SEMINOLE COUNTY GOVERNMENT
1101 EAST FIRST STREET, 2ND FLOOR, WEST WING
SANFORD, FLORIDA 32771

PROJECT NAME:	BEAR LAKE TER - PRE-APPLICATION	PROJ #: 24-80000021
APPLICATION FOR:	DR - PRE-APPLICATION DRC	
APPLICATION DATE:	2/27/24	
RELATED NAMES:	EP BRENDA PEARCE	
PROJECT MANAGER:	KATHY HAMMEL (407) 665-7389	
PARCEL ID NO.:	19-21-29-506-0000-0420	
PROJECT DESCRIPTION	PROPOSED SPECIAL EXCEPTION FOR A NEW WATER METER SYSTEM ON 0.24 ACRES IN THE R-1A ZONING DISTRICT LOCATED ON THE SOUTHEAST CORNER OF BEAR LAKE TER, SOMBERO AVE	
NO OF ACRES	0.24	
BCC DISTRICT	3: CONSTANTINE	
CURRENT ZONING	R-1A	
LOCATION	ON THE SOUTHEAST CORNER OF BEAR LAKE TER, SOMBERO AVE	
FUTURE LAND USE-	LDR	
APPLICANT:	CONSULTANT:	
BRENDA PEARCE BLACK & VEATCH/SUNSHINE WATER 200 WEATHERSFIELD AVE ALTAMONTE SPRINGS FL 32714 (678) 656-5179 PEARCEB@BV.COM	N/A

PROJECT AREA ZONING AND AERIAL MAPS

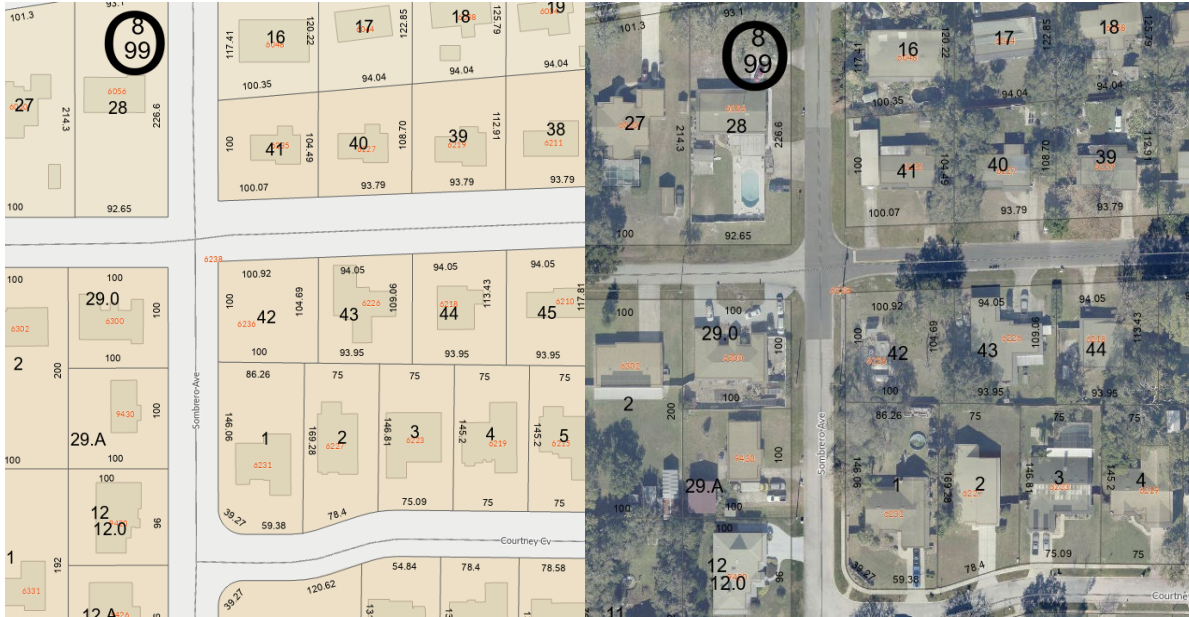
The parcel located within unincorporated Seminole County have a zoning classification of R-1A (Single Family Residential).

The installation of a pole with an antenna for a new water metering system will require a Special Exception to allow the use in the applicable zoning district. A variance to the building/structure height of 35 feet may also be required.
